**DUKE POWER**

Subject: McGuire Nuclear Station, Units 1 and 2  
Docket Nos. 50-369 and 50-370  
ASME Section XI Hydrostatic Testing Requirements  
Relief Request No. 89-02, Revision

DUKE POWER COMPANY  
McGUIRE NUCLEAR STATION, UNITS 1  
REQUEST FOR RELIEF FROM ASME CODE SECTION XI REQUIREMENTS  
RELIEF REQUEST NO. 89-02

THIS DRAWING APPLIES TO NSM'S MG-12243 Rv.0 + MG-22243 Rv.0

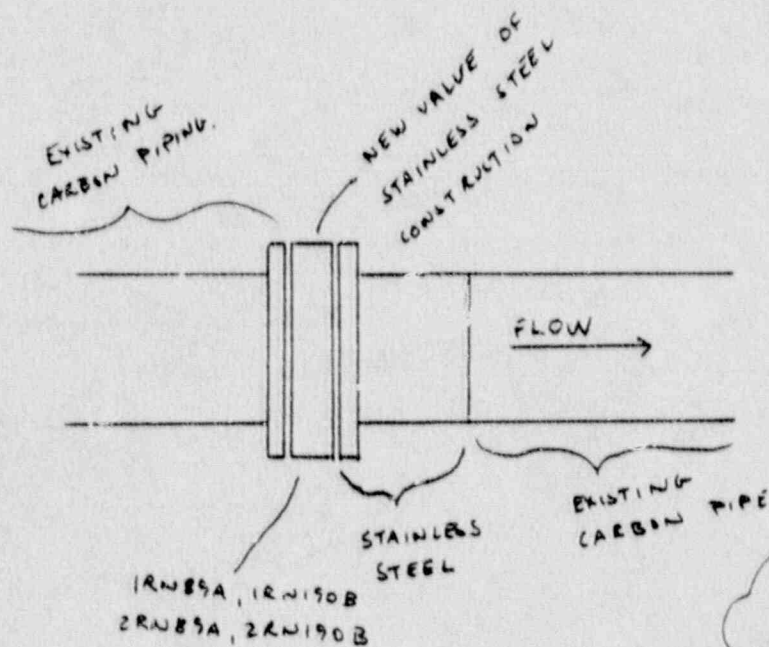
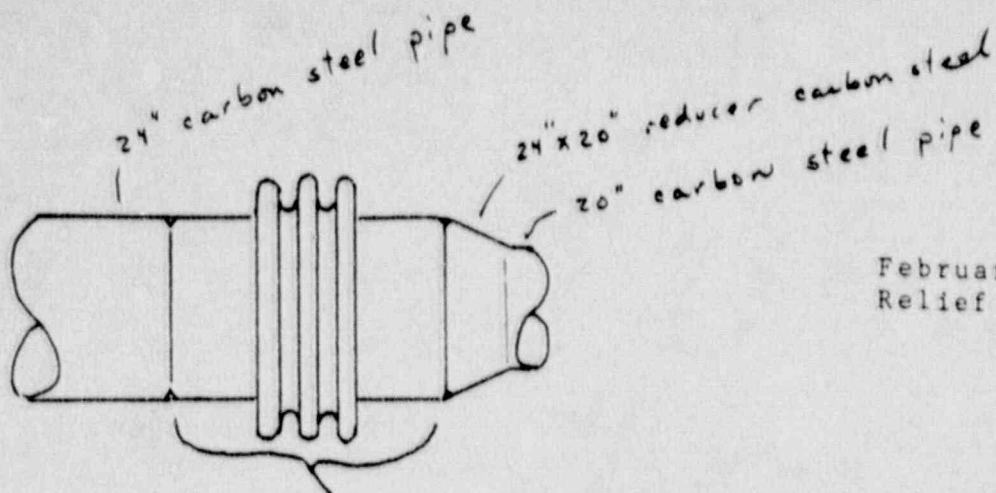
EXEMPTION IS NEEDED  
FOR ALL WELDS AND  
FLANGE CONNECTIONS ASSOCIATED  
WITH THESE MODIFICATIONS.

All welds will be subjected to a dye penetrant (PT) or a magnetic particle (MT) examination on the root pass and on the finished weld. An in-service leak test will also be performed at normal system pressure.

THIS DRAWING APPLIES TO NSM MG-2213D R.0

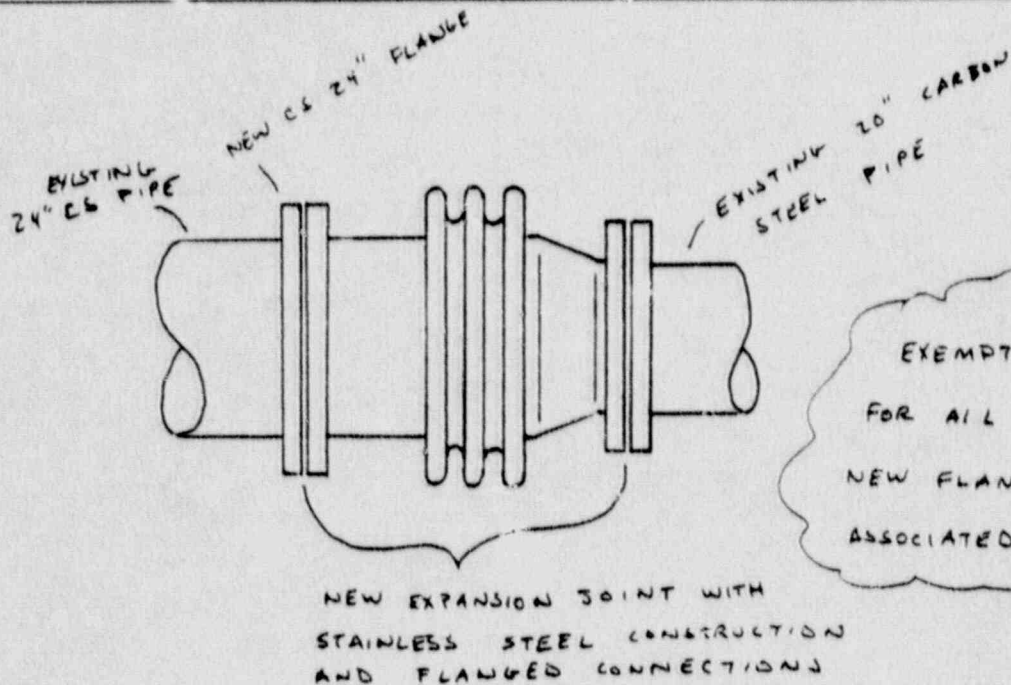
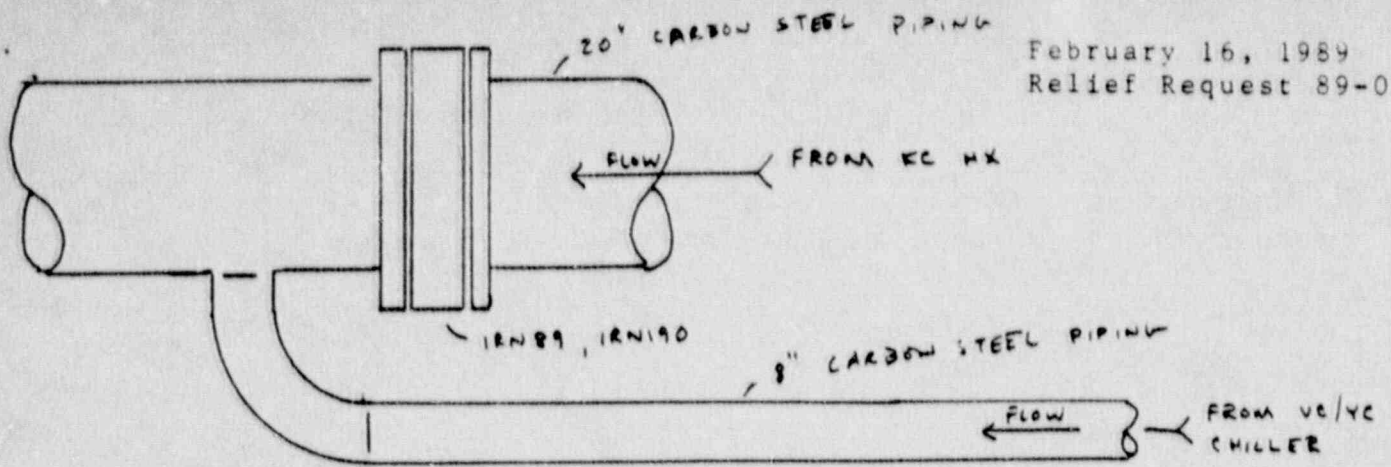
EXEMPTION IS NEEDED  
FOR ALL WELDS AND  
NEW FLANGE CONNECTIONS  
ASSOCIATED WITH THIS MOD.

Piping Configuration After Implementation of  
 MG-12243 and MG-22243 Modifications

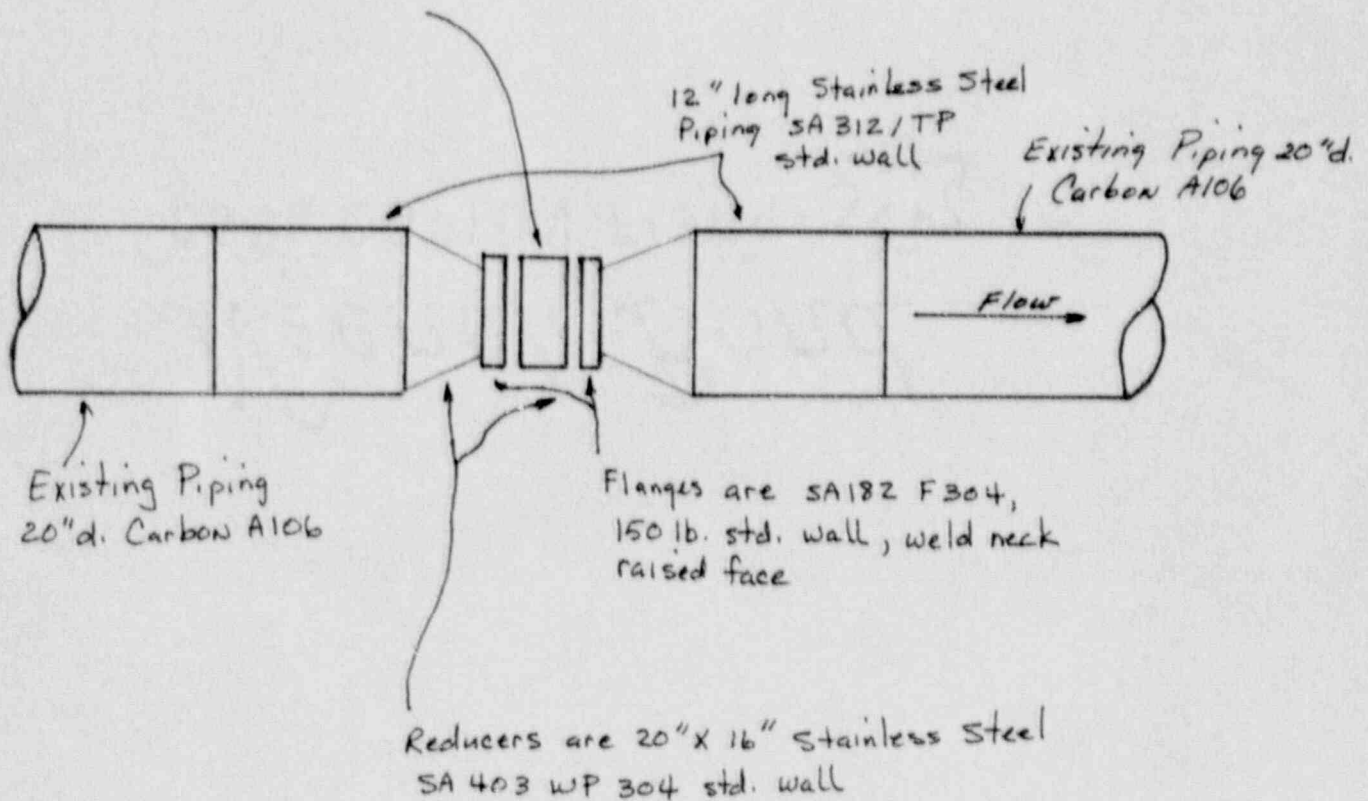
In the original scope of the modifications, we planned to replace an existing valve with a new stainless steel (SS) valve of the same size (20 inch), and add a 12 inch length of SS pipe to the outlet side of the valve to mitigate the effects of erosion (see Attachment No. 1.) Our subsequent plans are to use a 16 inch SS valve, two 16 inch by 20 inch SS reducers, and a 12 inch SS pipe installed on the inlet side of the valve as well as the outlet side of the valve (see Attachment No. 3). Our decision to use the smaller sized valve is based on improved valve performance. Currently, when operating this system, the 20 inch valve is throttled at approximately 15% open. The 16 inch valve can be throttled open at greater than 15% reducing flow impingement on the outlet side of the valve, thereby reducing erosion.

New valves are 16" of Stainless Steel construction,  
 for 1RN89A, 1RN190B, 2RN89A, and 2RN190B

We request that NRC staff approval of our original Relief Request be extended to include the changes to modifications MG-12243 and MG-22243. The original basis for our request for relief from hydrostatic testing is still valid. Hydrostatic testing is impractical due to the inadequacy of the test boundaries. The hydrostatic test boundary isolation valves include 36 inch, 20 inch, and 18 inch butterfly valves. These valves have a history of leakage and do not offer adequate isolation to permit a hydrostatic test.

In lieu of hydrostatic testing, all welds in the modification will be subjected to a dye penetrant or magnetic particle examination on root pass and finished weld. In addition, an in-service leak test will further verify the new connections do not leak.
